BULLI SEAM OPERATIONS

PAC REPORT

JULY 2010

The Minister for Planning referred the Project Proposal to the Planning Assessment Commission (PAC) for review and advice on the significance and acceptability of the potential subsidence related impacts of the project on significant natural features, built infrastructure and the values of Sydney's drinking water catchment, and for recommendations as to appropriate measures to avoid, control, or offset these impacts. The Minister also requested that the PAC hold public hearings and provide comment on issues raised in submissions and public hearings.

Figure 9: Model Utilised in the EA to Calculate the Height of the Fractured Zone

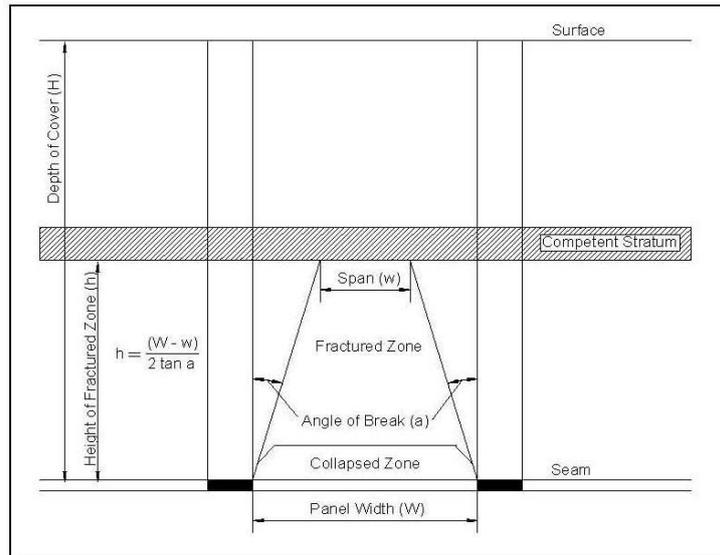
The model is empirical and as for all empirical models, considerable care has to be exercised in extrapolating it to conditions outside those of the database used to derive and calibrate it. The raw database is not presented in the EA but Figure 10³⁰ shows the plot used to calibrate the model to data reported in literature. On the basis of this plot, Appendix A concludes that *'the height of the fractured zone in the data base is reasonably well presented by the theoretical model (Equation 1) using an angle of break of 20 degrees'*. When this value of 20° is substituted into Equation 1, it reduces to:

Figure 10: Height of the Fractured Zone as a Proportion of the Panel Width for Different Panel Width to Depth Ratios³¹

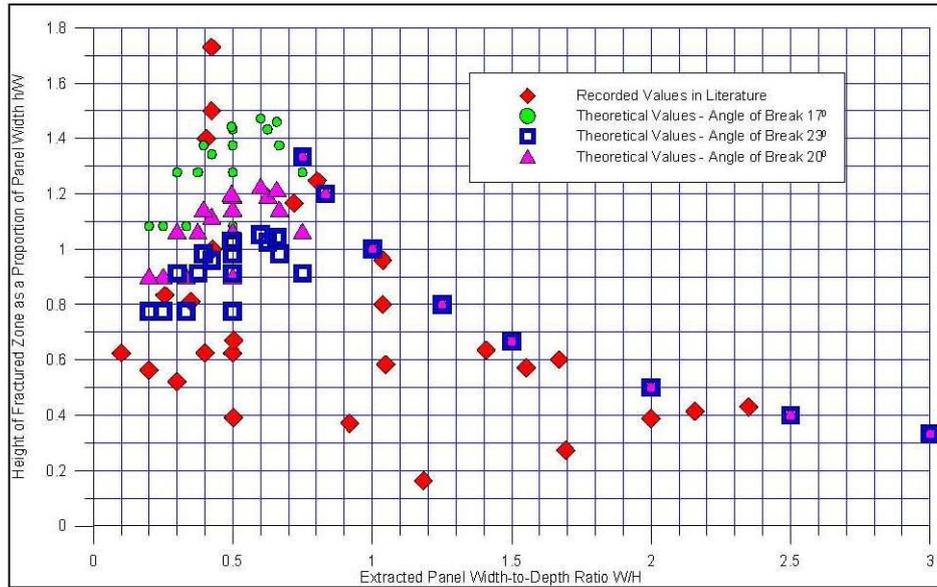
- The manner in which the data have been plotted in Figure 10. Since the plot is intended to illustrate the correlation between the recorded height of the fractured zone in the field and that predicted by MSEC's model for angle of breaks of 17°, 20° and 23°, four outcomes should be plotted against the width to depth ratio (W/H) corresponding to each field data point. Figure 10 does not depict this.

- The conclusion that the height of the fractured zone in the data base is reasonably well presented by the theoretical model. Based on the trend in Figure 10 of the predicted height of the fractured zone at different panel width to depth ratios, the recorded height of the fractured zone for more than half of the data points is less than 50% of that predicted by the model.

- The discounting of the data points represented in Figure 10 by the three red diamonds that have a panel width to depth ratio of around 0.4 and a recorded fractured zone height of that falls well above that predicted by MSEC's model. These data points relate to Longwall 2 at Ellalong Colliery and Longwall 3 at Tahmoor Colliery. Ellalong Colliery operated the deepest longwall panels to date in Australia, whilst Tahmoor Colliery extracts the Bulli Seam to the south west of the BSO Study Area. It is plausible, therefore, that these three points may have been more representative of the BSO situation than the points in the data set.

Figure 11: Relationship between Measured Curvature and Measured Strain Recorded during the Extraction of Longwalls in the Southern Coalfield⁵⁴

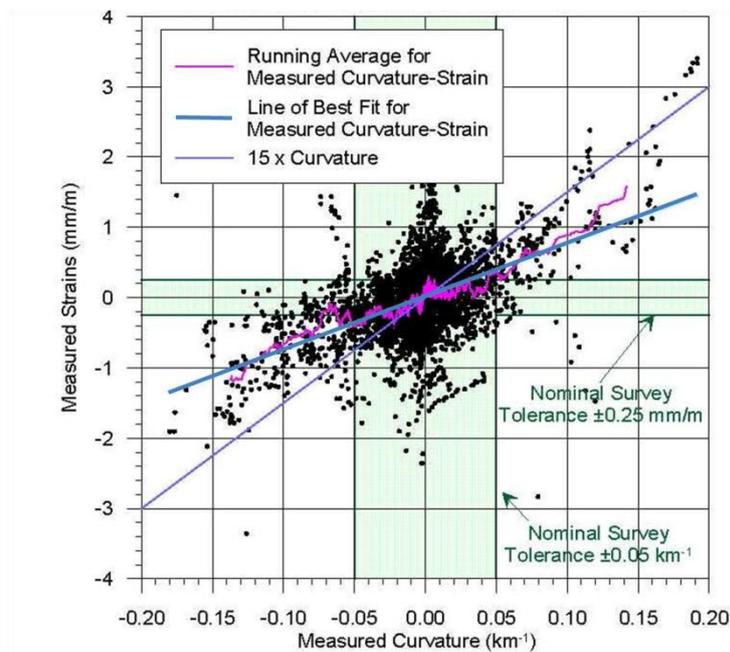
Throughout the EA, it is erroneously stated that applying a factor of 15 to the maximum curvature provides a reasonable estimate for the *average predicted strain*⁵⁰. As reference to Figure 11 shows, in fact it provides an estimate of the *maximum* strain for hogging and sagging curvatures greater than 0.05 km^{-1} , which is consistent with the manner in which this relationship has been used for many years in NSW. Figure 11 also shows that this approach produces a reasonable upper bound prediction for compressive strains but underestimates upper bound tensile strains by 15 to 20%. DECCW raised this issue in one of its submissions to the Panel, stating that the relationship was '*clearly non-linear [sic] and does not adequately capture the variation in data*'⁵¹. ICHPL responded that '*This figure [Figure 11] shows that this linear relationship provides a reasonable estimate of strain, and is particularly*

As reference to Figure 11 shows, the relationship does not provide an upper bound prediction of tensile strain.

Figure 14: Correlation between Predicted Total Closure and Total Upsidence at Time of Pool Impacts in the Southern Coalfield⁷⁶

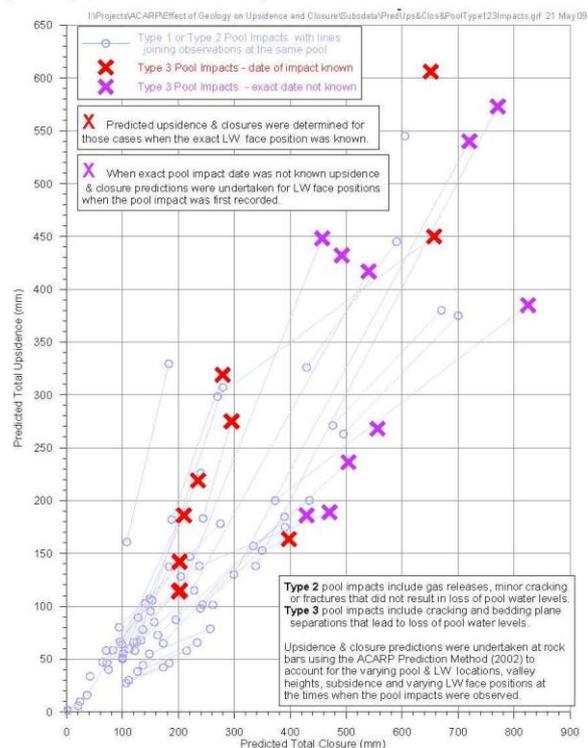
Appendix A reports that Figure 14 ‘*indicates that no pool impacts have been observed, to date, where the predicted total closure was less than 200 mm*⁷⁸’. Based on the database accumulated to date, it concludes that there is around a 10% probability of a Type 3 impact being associated with a 200 mm to 215 mm closure range. The Panel concurs with this finding but notes that it is sensitive to the size of the database and the timely detection of impacts. Therefore, the probability may increase or decrease as more case studies become available.

Figure 21: Revised differential drawdown in lower Hawkesbury Sandstone¹¹⁸

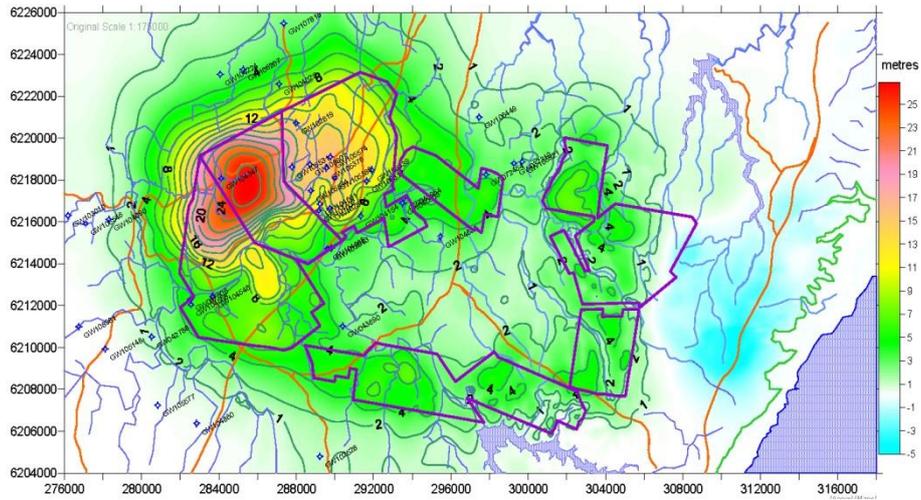
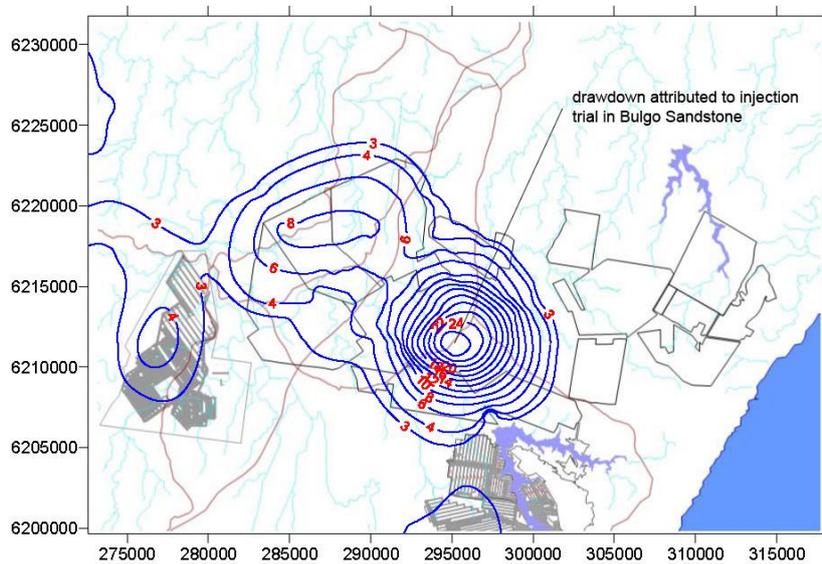
Revised drawdown plots generated for the end of mining differ significantly from plots provided in the EA. An example can be found in the lower Hawkesbury Sandstone where numerous existing boreholes were identified by the proponent as being at risk. Figure 20 provides output from the EA¹¹⁵ which clearly shows significant drawdown attributed to mining in Area 8 and Area 9 with a maximum 26 m indicated in the north-eastern part of Area 8. The remainder of the Project Area exhibits drawdowns (relative to the commencement of the Base Case mining) of the order of 1 to 4m. The consequences of significant drawdown relate almost entirely to bore water supplies insofar as there may be significant loss of yield at boreholes situated within this province.

In contrast, Figure 21 provides output for the revised model which shows much reduced drawdowns ranging from 3 to 8 m in Area 8 and Area 9 or about one third the impacts represented in the EA. However, a significant drawdown of up to 26 m is

indicated adjacent to and north of Area 3, and extending southwards into Area 3. This feature is reportedly associated with the Bulgo Sandstone injection trial (decay of the elevated pore pressure regime following cessation of injection) and should not affect other stakeholders. ICHPL seem to have inadvertently omitted the injection trials from the original modelling. The much reduced drawdowns in Appin Area 8 and Area 9 suggest yield related impacts on the 40 identified boreholes¹¹⁶ accessing groundwater from the lower Hawkesbury Sandstone would be significantly reduced but not removed when compared to the original EA predictions. Boreholes located in shallower strata are unlikely to be yield affected according to the revised model.

Figure 26: Boundaries Defining Area A

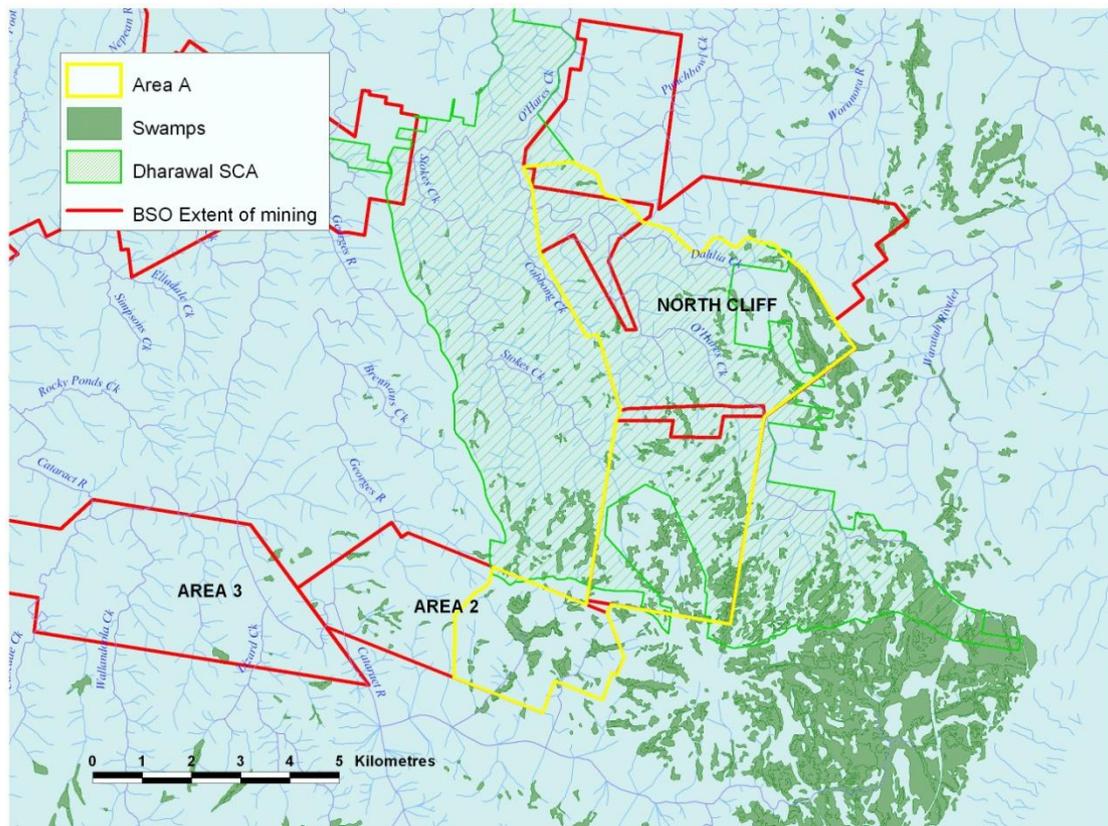
- (i) Mining not be approved for the area marked A on Figure 26;
- (ii) Upland swamps in the area marked A on Figure 26 be protected by requiring as part of any Approval, a performance criterion of negligible subsidence-related impact. This means that:

- (iii) Mining be approved in the area marked A on Figure 26, but with a negligible impact requirement for the swamps listed below plus any other swamps in Area A found to contain EECs or threatened species after comprehensive survey and which are considered by DECCW²⁵¹ to meet the test of special significance based on the conservation significance of those findings either alone or in combination with other values. The swamps identified currently are:

The differences between (ii) and (iii) are probably relatively small in terms of impact on the mining operation, but (ii) would be much simpler to administer.

Figure 35: Predicted Valley Closure Movements along O'Hares Creek, Dahlia Creek and Stokes Creek

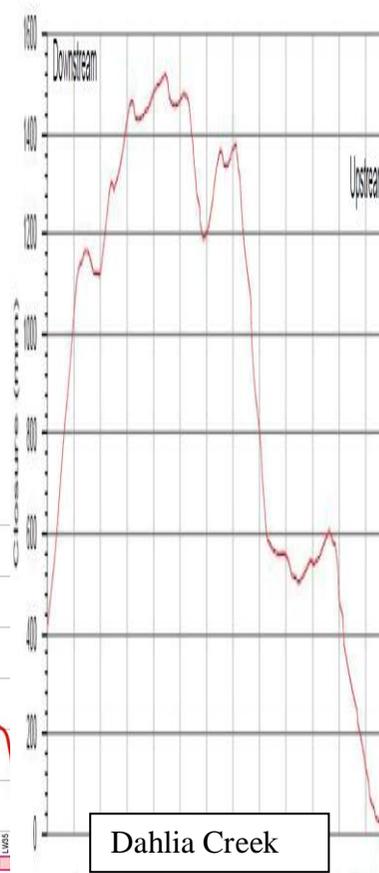
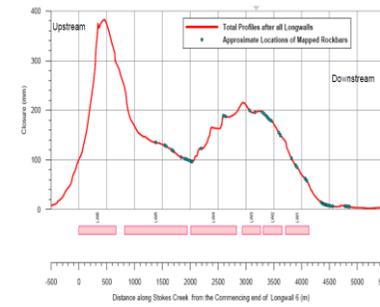
- The EA assesses variable levels of protection as appropriate to different creeks in this zone, even where, by the Panel's assessment, values appear similar. For example, Figure 35 compares predicted closure for O'Hares Creek, Dahlia Creek and Stokes Creek. The predicted closure figures have been copied from Appendix C of the EA and adjusted and placed on the page to align vertical scales. Photos have been added to allow a quick visual comparison. While these three streams represent different sizes of channel, the Panel cannot accept that allowing such different levels of impact is defensible for otherwise similar streams.
